Service Bulletin

Bulletin Number: **SB-20-333-2 Revision B (2 of 2 Bulletins)**
Release Date: **December 29, 2020**
Distribution: **Heil Dealers, Heil Technical Services, Heil Customer Care, Heil Sales Team**
Subject: **Half/Pack® and Half/Pack® (Featuring Odyssey® Controls): Front Head Manifold Hydraulic Tube Failures**

Figure 1. View from Below Body of “Old” and “New” Front Head Hydraulic Configurations

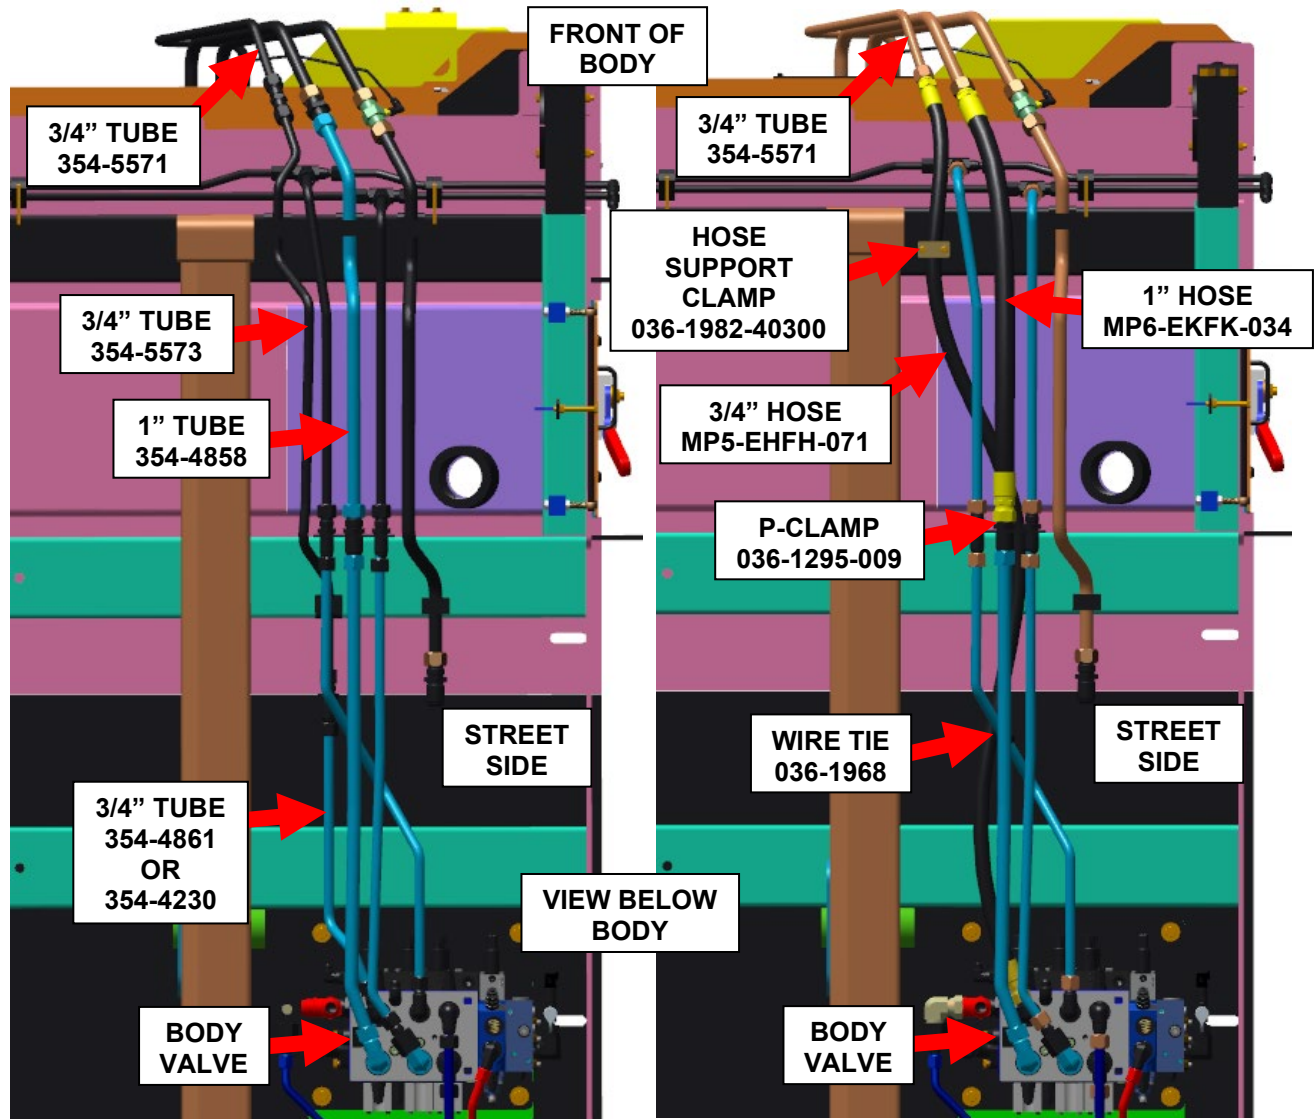
“OLD” FRONT HEAD HYDRAULIC CONFIGURATION

Replace the tubes called out below. Note that 3/4” Tube (354-5571) will be replaced with a revised 3/4” Tube (354-5571), with same part number.

“NEW” FRONT HEAD HYDRAULIC CONFIGURATION

Note the two hoses that have replaced three tubes.

- (1) Install a new revised 3/4" Hydraulic Tube (354-5571). Torque fittings to 84 FT-LBS.
- (2) Install a new 3/4" 4-Wire Spiral Hydraulic Hose (MP5-EHFH-071), routing from 3/4" Hydraulic Tube (354-5571) to body valve, replacing Hydraulic Tube (354-5573) and Hydraulic Tube (354-4861) for Half/Pack (featuring Odyssey Controls) or Hydraulic Tube (354-4230) for Half/Pack, along with union fittings. Torque fittings to 84 FT-LBS.
- (3) Install a new 1" 4-Wire Spiral Hydraulic Hose (MP6-EKFK-034), replacing Tube (354-4858) and union fittings. Torque fittings to 118 FT-LBS.
- (4) Install hydraulic hose support clamp covers using LOCKTITE® Red Threadlocker on the clamp bolts.
- (5) Check ALL existing underbody tube clamp bolts to ensure they are properly tightened, ensuring they will not become loose from vibration over time. Use LOCKTITE® Red Threadlocker as needed.

Figure 3. "Old" Mounting Brackets

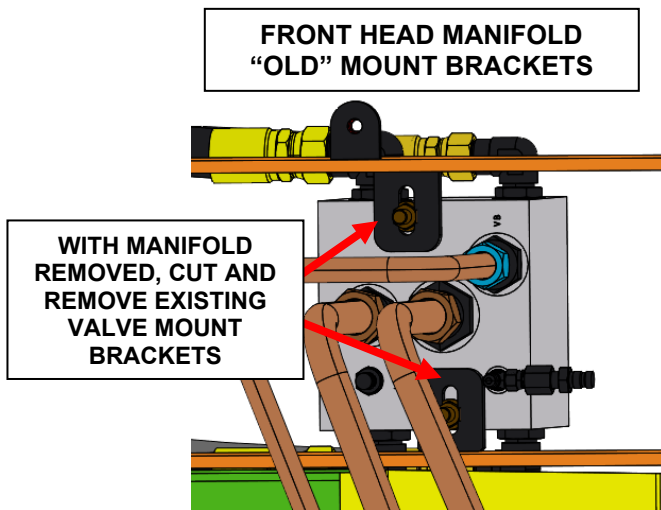
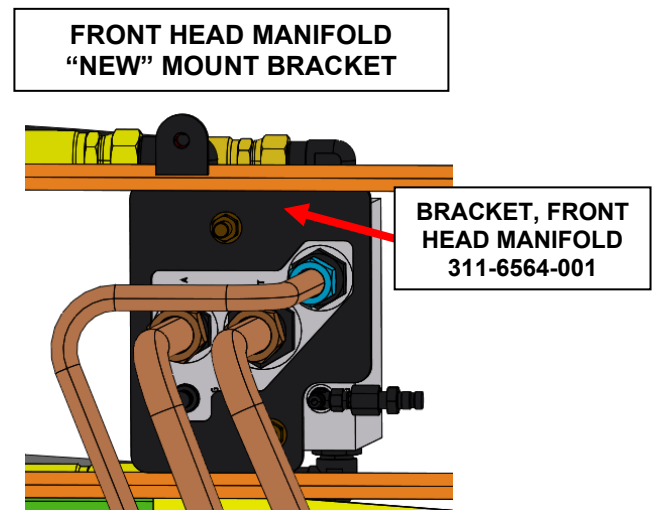
Inspect front head manifold mounting tabs for cracks. **Only if cracks are present**, follow the procedure below to cut off tabs and replace with Front Head Manifold Bracket (311-6564-001).

- (3) Using a metal cut-off wheel, cut off the existing two manifold bracket mounting tabs.
- (4) Place the Front Head Manifold Bracket (311-6564-001) into position between the two horizontal plates as shown in **Figure 5**, 23.51" from the vertical side plate to the bracket bottom side, and then weld a 3/16" continuous fillet, two places.

Figure 6. Install Front Head Hydraulic Hose Support Bracket (Measurements Shown in Inches)

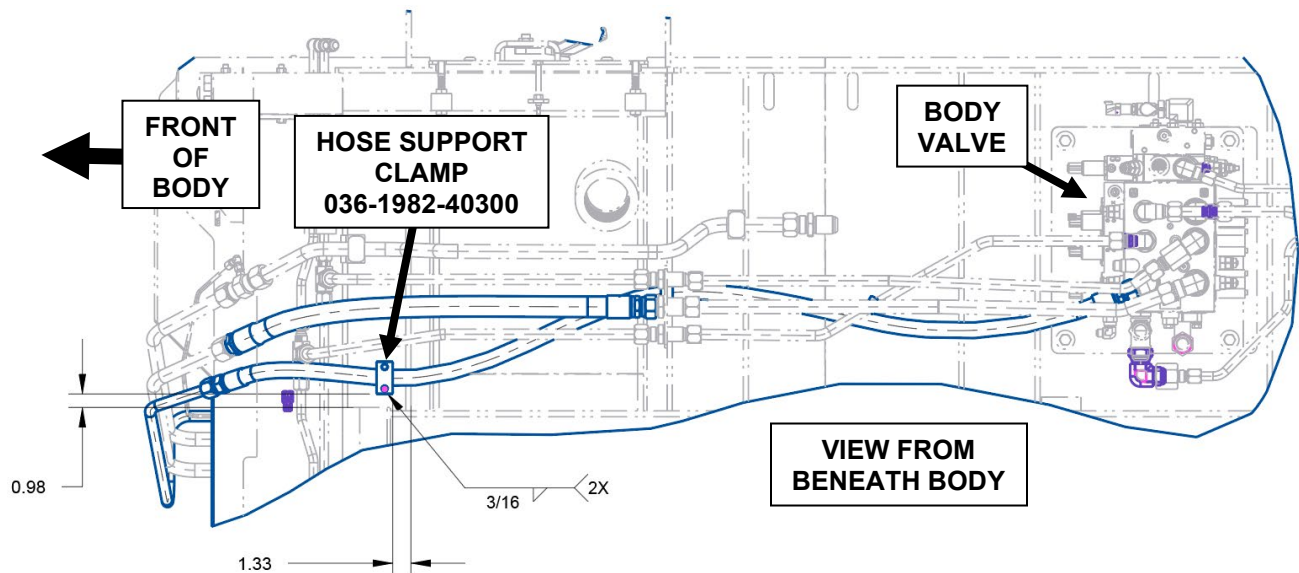
(1) Weld new Hose Support Clamp (036-1982-40300) onto the body crossmember as shown in **Figure 6** (without the hose installed). Once cooled, sand welds smooth, remove any weld spatter, and then clean and paint all exposed metal and weld.

Figure 7. Weld Details for Hose Support P-Clamp (036-1295-009)

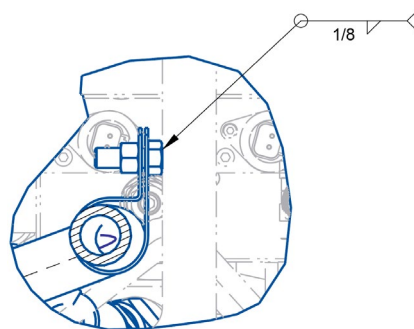
(2) Install Wire Tie (036-1968) and Hose Support P-Clamp (036-1295-009) in the locations shown in **Figure 1**. Also see **Figure 7** for Hose Support P-Clamp weld details.

Figure 8. Spill Guard (035-3764) Installation Location

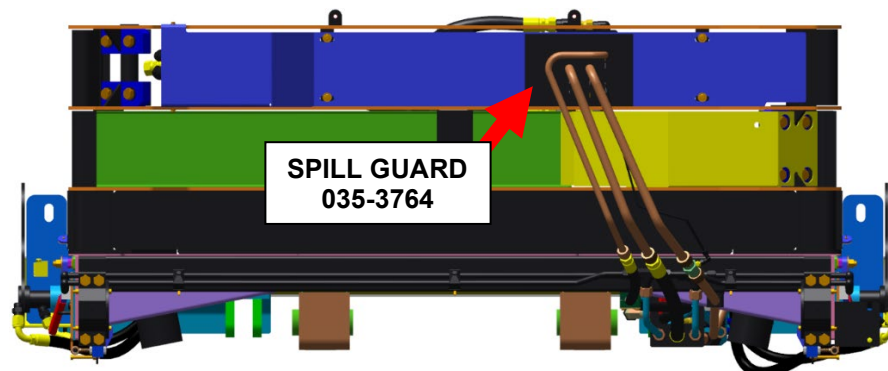
- (1) Take the unit out of Lock-Out/Tag-Out Mode.
- (2) Operate all unit functions. Then check for leaks. If there are leaks, loosen and re-torque the hydraulic fittings that are leaking and then check again for leaks. When there are no leaks, check hydraulic oil level and add oil if needed. Contact Technical Services if leaks continue. **DO NOT REUSE THE HYDRAULIC OIL DRAINED FROM THE SYSTEM DURING DISASSEMBLY.**
- (3) Reinstall the upper front head enclosure using the six (6) bolts and associated hardware from Step 3.A.(4). See **Figure 2**.
- (4) Install the Spill Guard (035-3764) and Spill Guard Support Bracket (311-6871-001) to front head cover plate using four (4) self-drilling Tek Screws (047-2151-011). The Spill Guard Support Bracket runs along the bottom of the Spill Guard. See **Figure 8**.
